FIELD ENGINEERING BULLETIN

TITLE: OCCASIONAL UNTHREADING OF SERVO SYSTEM
FROM FAST TO PLAY MODE

REF. NO. 70198

MODEL ATR-100

FIG I

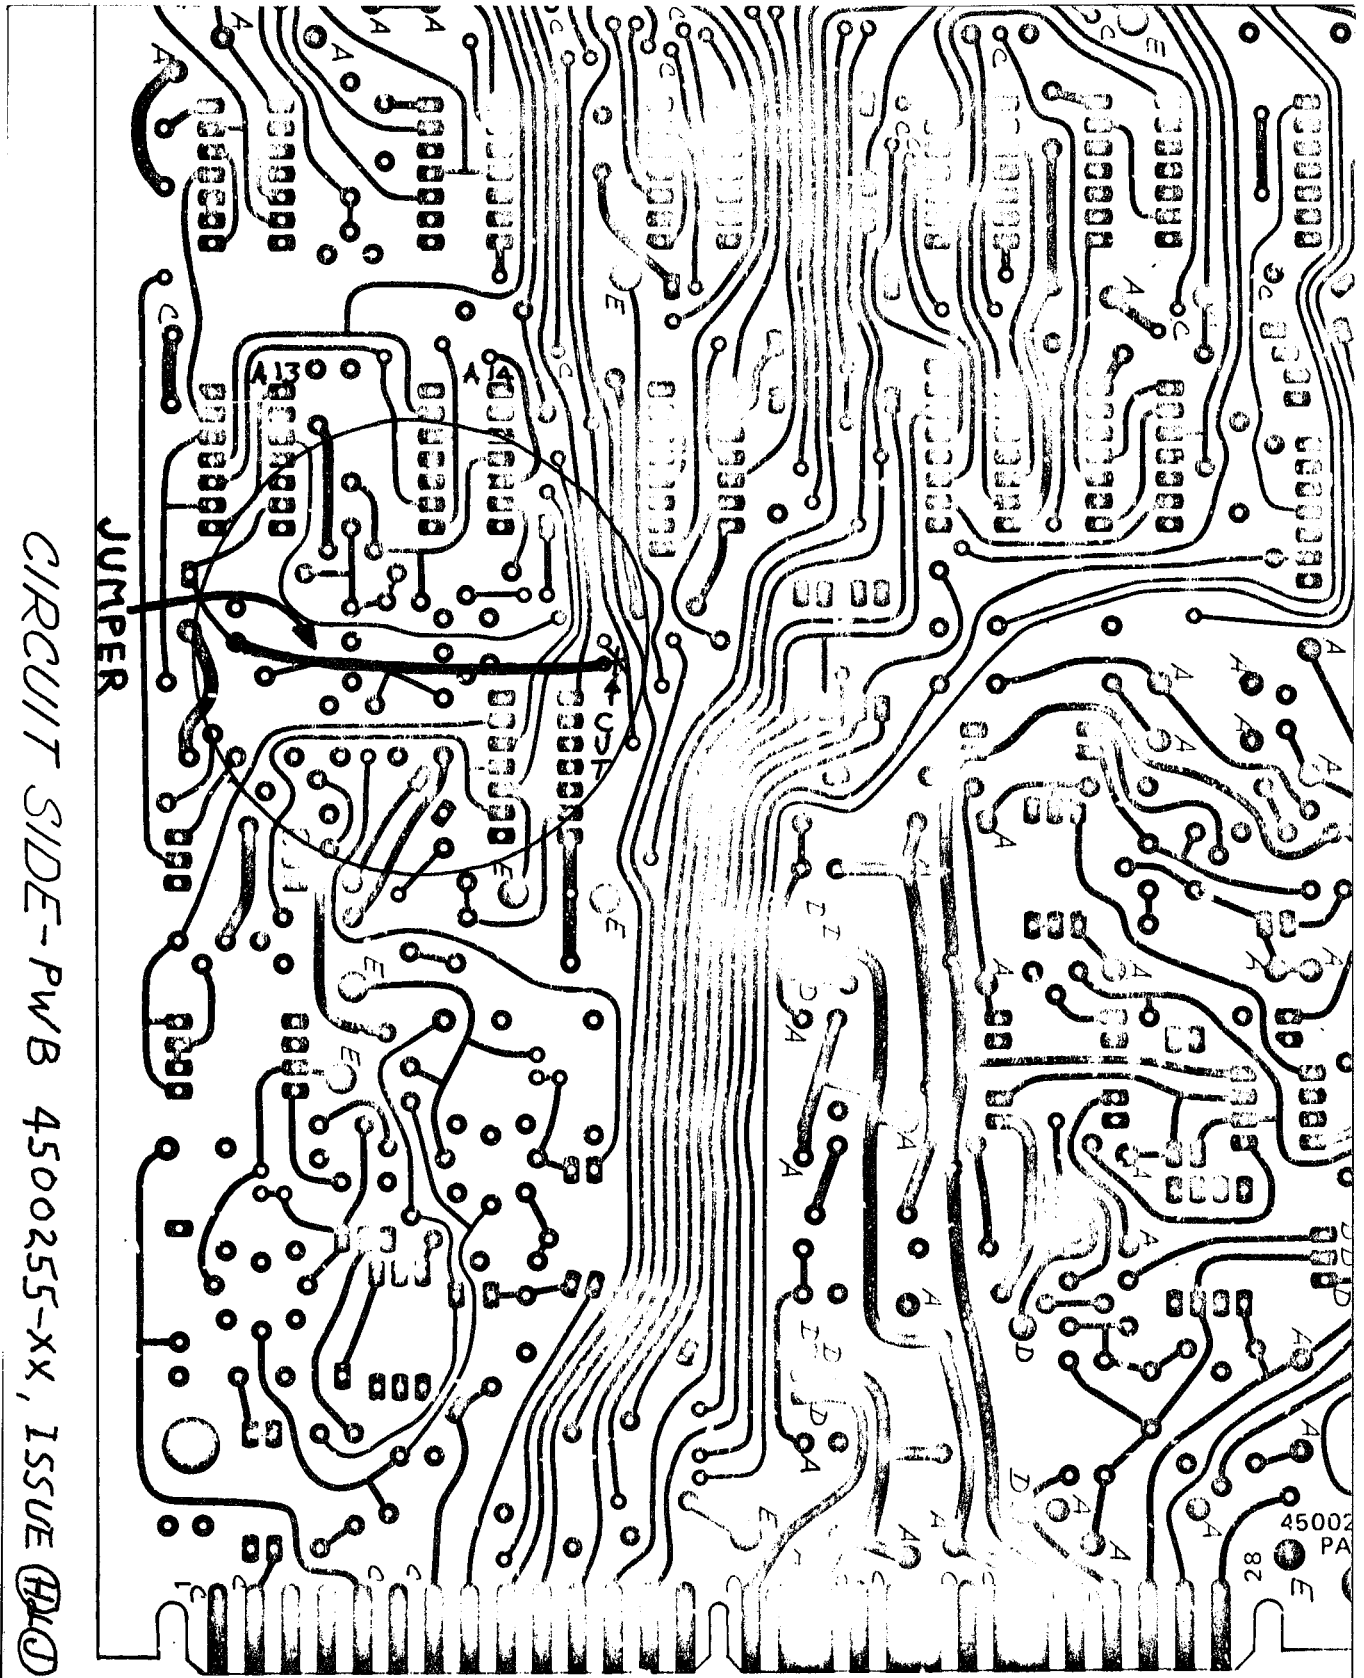
Remove the PWA from the shield. On the circuit side of the board, along side Pin 28, is the P/N 4500255-XX. Just below this is the issue letter of the board. Issue letters H and J only should be modified.

Locate the short trace connecting R94 to A14-3. (See fig. I). Cut trace per dwg. and install short insulated jumper from R94 to A13-6. Re-install PWA onto shield and check for proper operation of the capstan servo. No re-adjustment of the servo system is necessary.

FIG II

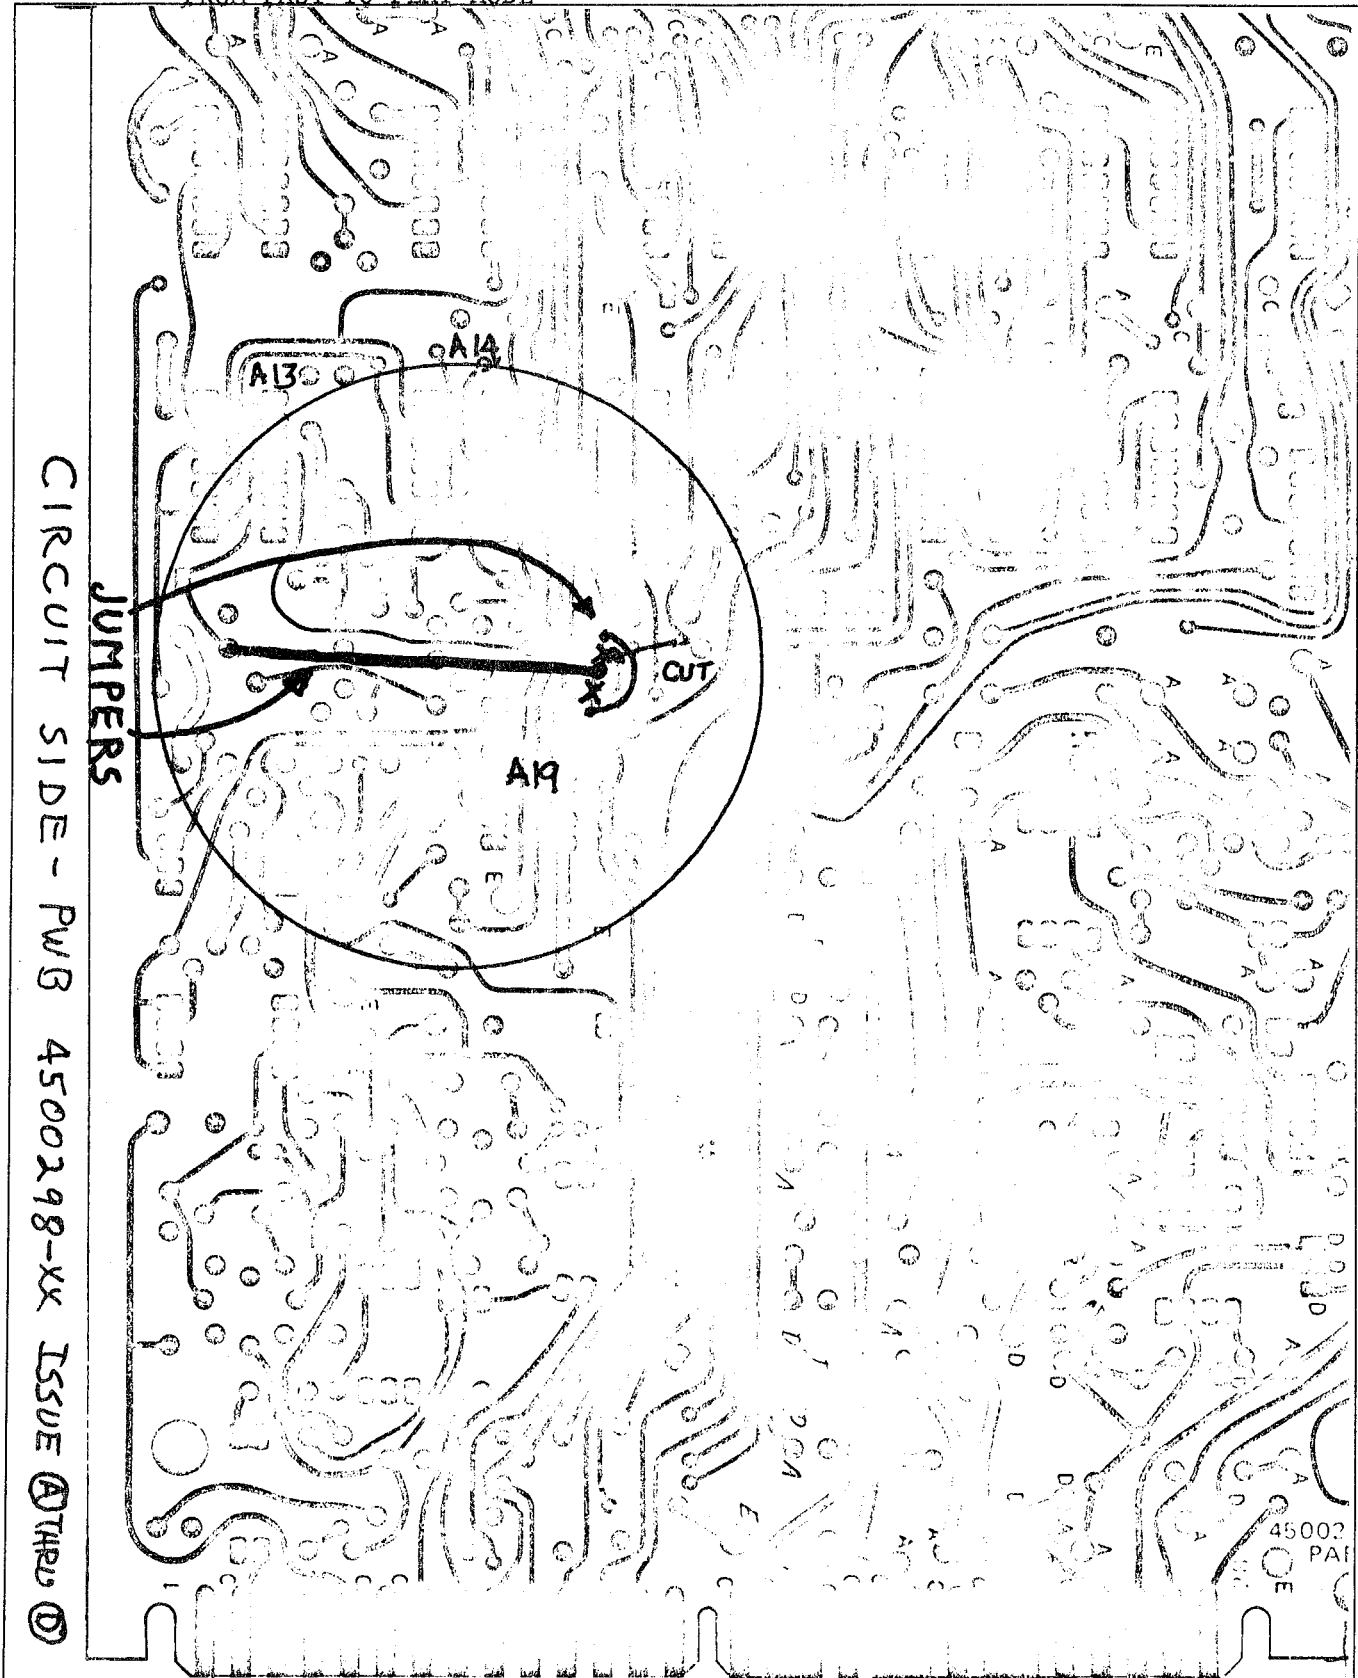
Remove the PWA from the shield. On the circuit side of the board along side Pin 28, is the P/N 4500298-XX. Just below this is the issue letter of the board. Issue letters A thru D need to be modified. Issue letters E and later have had the circuitry changed, and do not require this modification.

Locate the trace connecting R94 to A14-3 (see fig. II)
Cut trace in two places per drawing and install a short
insulated jumper bridging the pad that R94 is soldered
to. With a longer insulated jumper connect from the R94
pad to A13-6 per drawing. Re-install PWA onto shield
and check for proper operation of the capstan servo.
No re-adjustment of the servo system is necessary.
